ATTACHMENT I

Comments from Federal Land Managers and EPA (with responses):

Description of Environmental Protection Agency (EPA) Comments on Connecticut’s Draft Regional Haze State Implementation Plan (SIP) and Connecticut Department of Environmental Protection (CTDEP) Responses

Figure 8.11: Annual Sulfur Dioxide (SO₂) Emissions, by State

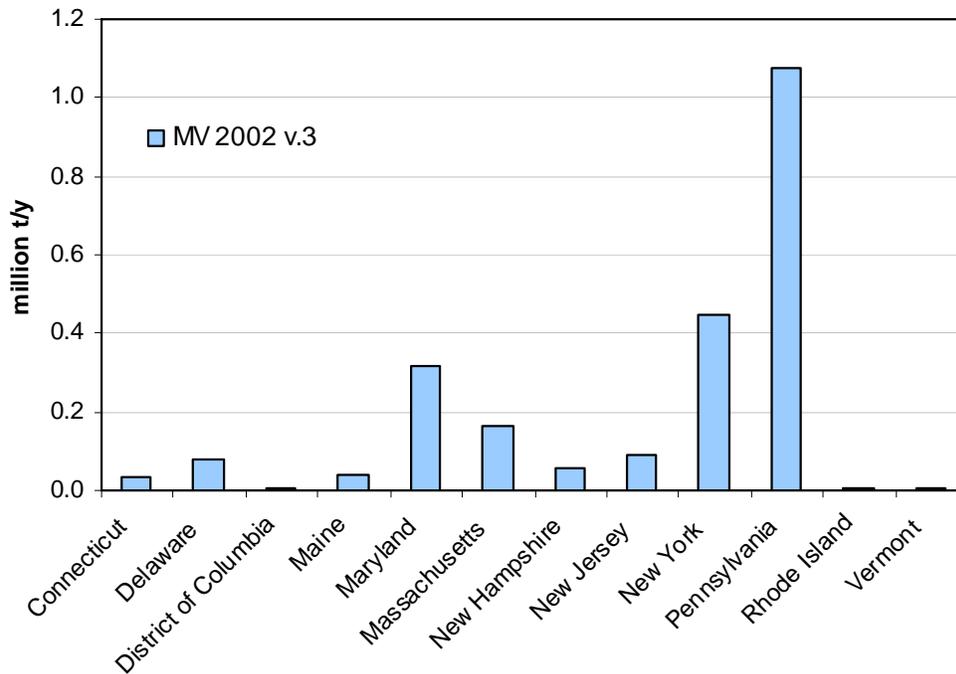
The reference cited for Figure 8.11 appears inaccurate. Please correct this reference.

In the second paragraph of Section 8.3.1, Connecticut states, "Most states in the region showed declines in annual SO₂ emissions through 2002 compared with those previous inventories." Connecticut should include the data that support this statement, refer to another document that contains the supporting data, or remove the statement.

CTDEP has reorganized and revised the text after the first paragraph in Section 8.3.1, Sulfur Dioxide (SO₂) as follows:

"Figure 8.11 shows SO₂ emissions in the MANE-VU states as extracted from the 2002 MANE-VU inventory (MARAMA, 2005).
